PRODUCT TECHNICAL BULLETIN

COALTRAM CT08 CT10 CT13

Exhaust Leak at the Exhaust Conditioner to Exhaust Pipe fixed joint

Ref Document No.	TB12001	Issue No.	1
Release Date	November 2012

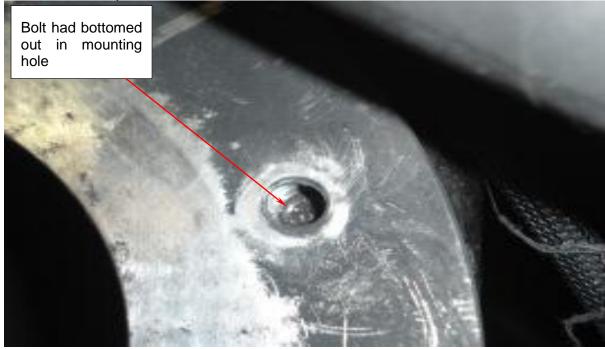
During a routine service the fixed joint was inspected using soapy water. Several small bubbles were observed at the joint between the gasket, exhaust conditioner and exhaust pipe. The vehicle was in service for over 6 months and had passed weekly checks.

Further investigations found that the vehicle was fitted with 3/8" x 1 1/4" (Part No 5530755000) socket head cap screws. The threads were binding in the exhaust conditioner mounting flange. When the bolts were removed from the exhaust conditioner mounting flange a witness mark was evident at the bottom of the blind threaded holes and on the end of the bolts.

The bolts binding, reduced the clamping pressure on the joint gasket and after a period of time an exhaust leak developed at the fixed joint. As the thickness of the scrubber flange may alter due to manufacturing processes, the overall depth of the bolt hole may vary, which in turn will determine the length of bolt required to allow sufficient thread engagement without binding.

The in service repair consisted of replacing the bolts with 3/8" x 1 $\frac{1}{8}$ " (part no. 5520003968) socket head cap screws and tensioned to rectify the issue.

- 1. All COALTRAM owners and end users are to contact the DMS Service Department to schedule an inspection as soon as practicable.
- 2. All end users are to inspect the exhaust conditioner to exhaust pipe joint on a weekly basis with soapy water to insure no exhaust leaks, until DMS have inspected the exhaust joint.
- 3. At the earliest opportunity the joint retaining bolts shall be individually removed by DMS Service Department personnel and inspected to ensure correct thread engagement without binding.
- 4. If there is evidence of bolts binding they are to be replaced with the shorter 3/8" x 1 1/8" SHCS bolts and tensioned. Installation procedures and verification check reports will be used by DMS Service Department to ensure a satisfactory outcome to the corrective action. Refer TB12001 Addendum Inspection Form
